108-124 Forest Road, Mixed-use Development

DA Architectural Drawing List

ISSUE STATUS		
REV	DESCRIPTION	DATE
1	DA ISSUE	16/12/20
2	RESPONSE COUNCIL RFI - AMENDMENTS AS NOTED	30/07/21

TITLE		
Height Diagram		
ISSUE	REV.	DRAWING NO.
DA	2	DA41

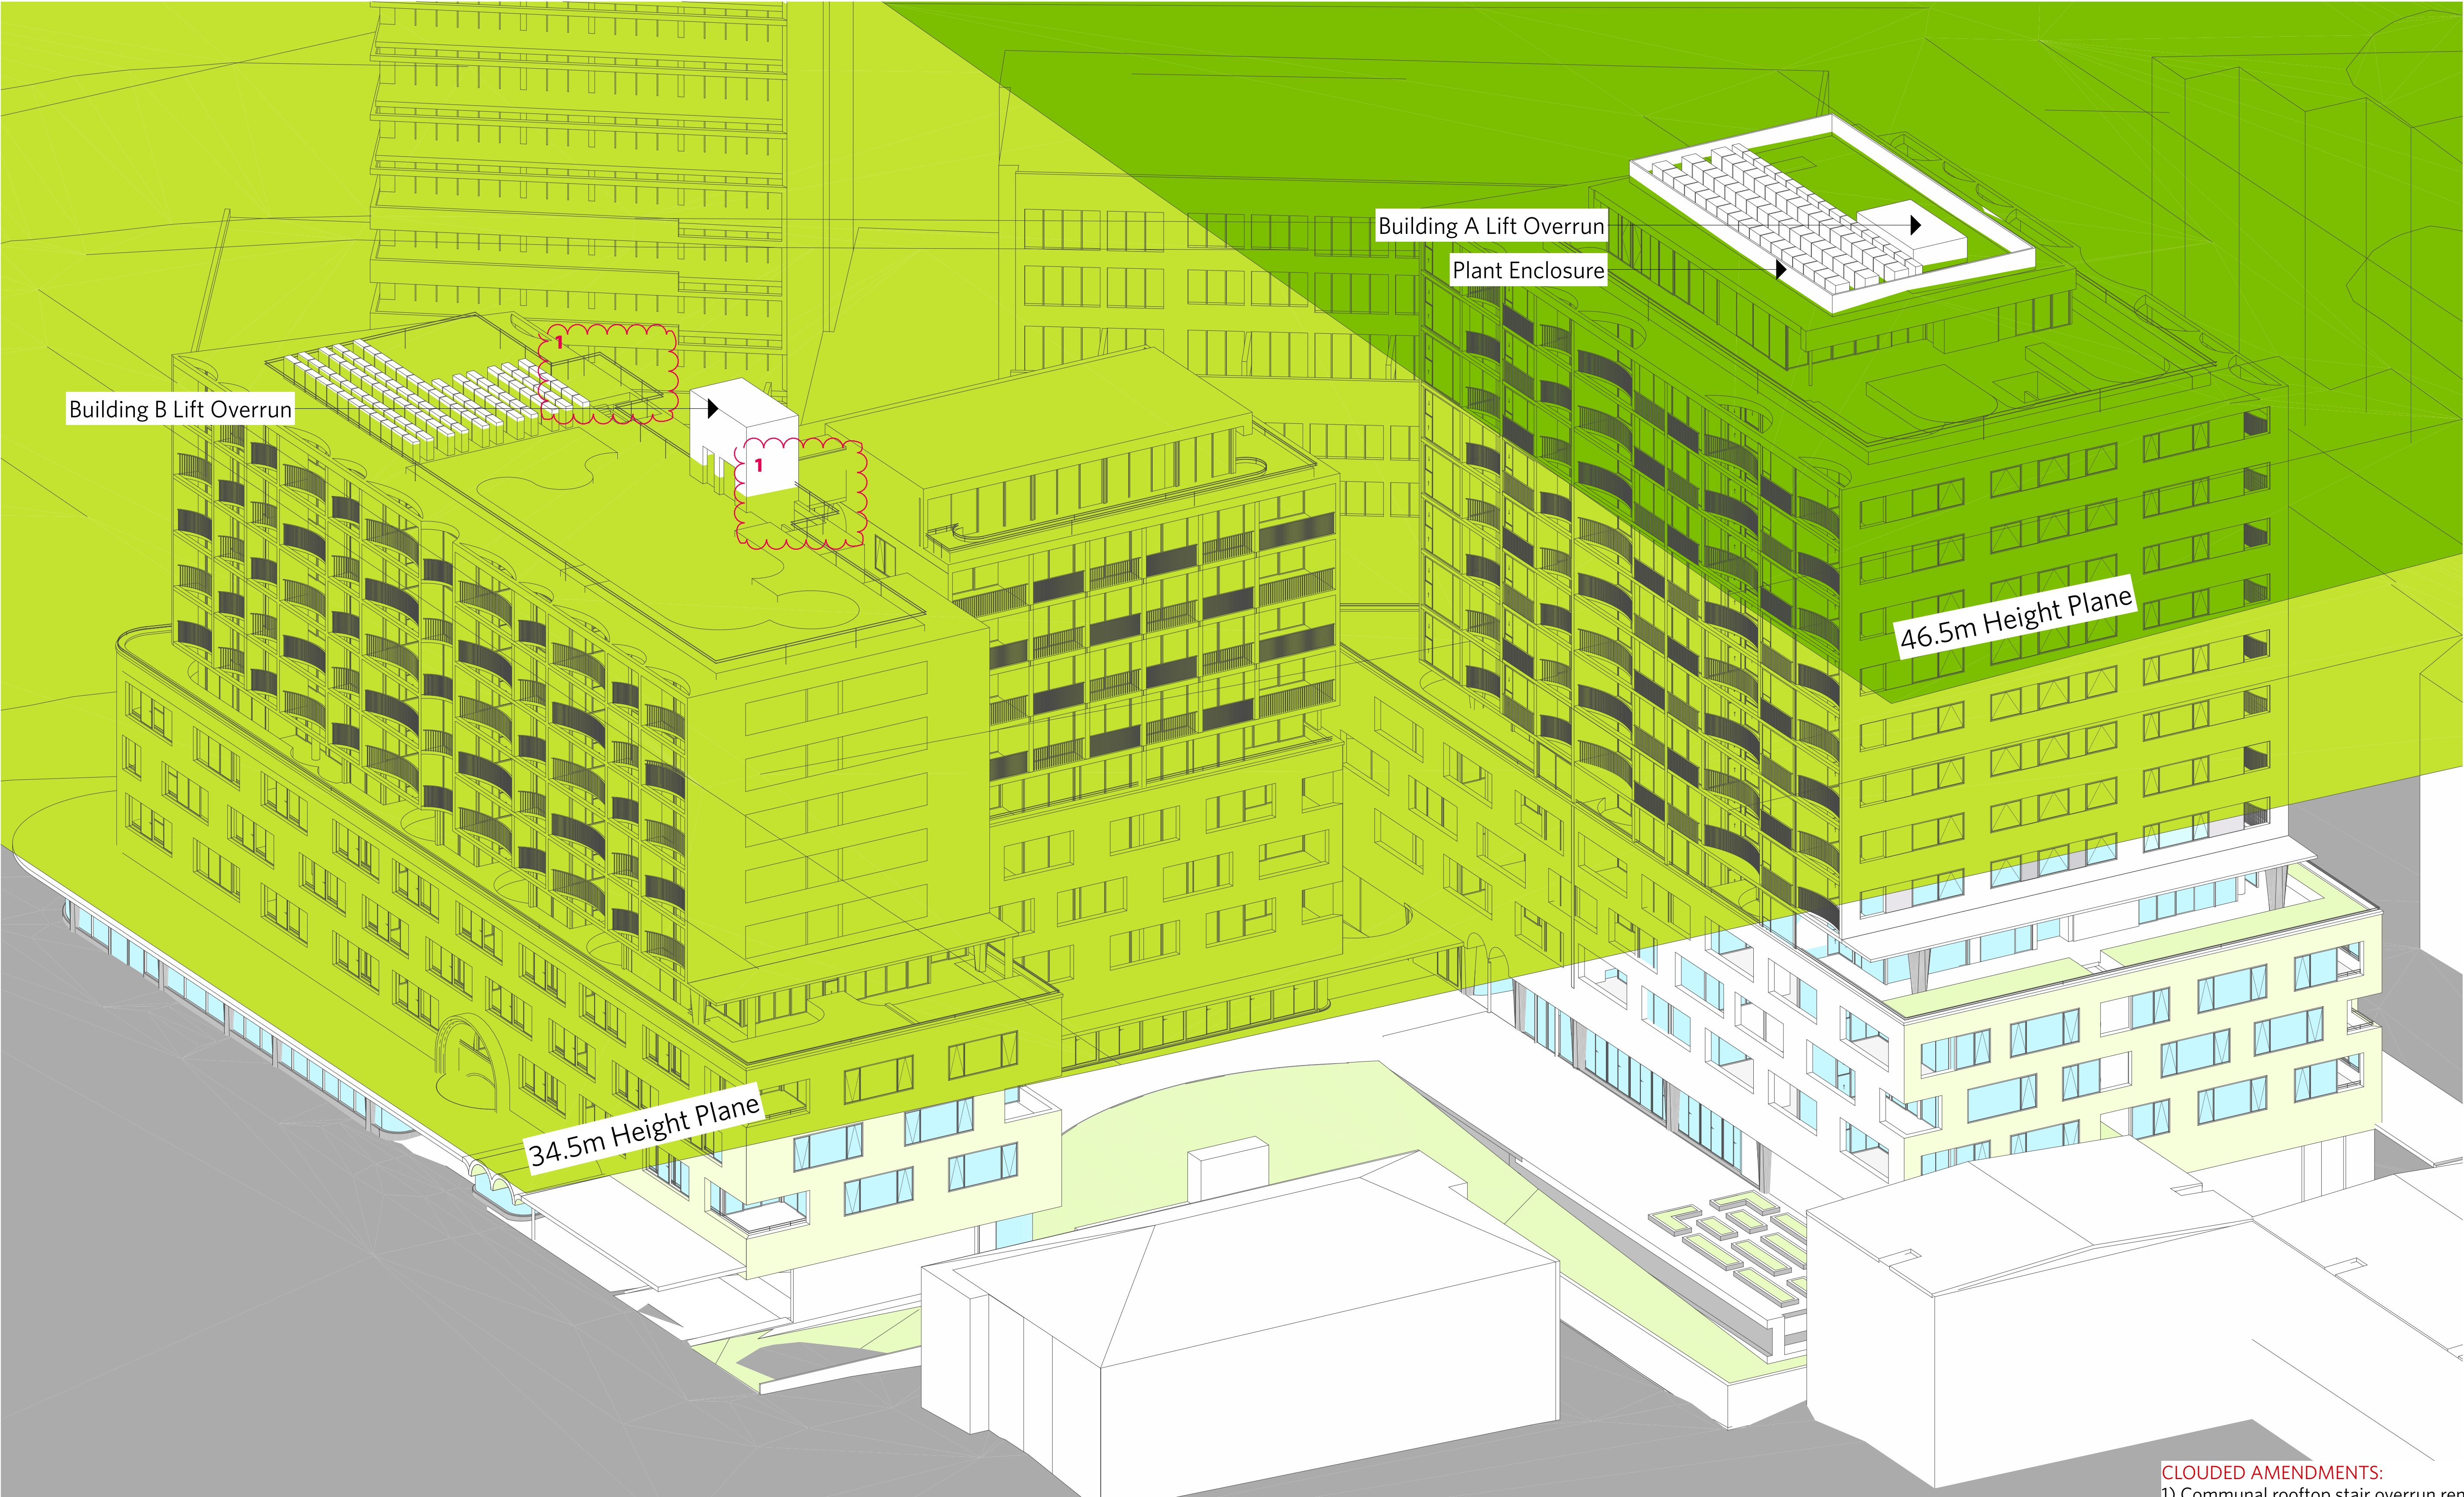
CLOUDED AMENDMENTS:
1) Communal rooftop stair overrun removed. Egress provided with secure door at level below
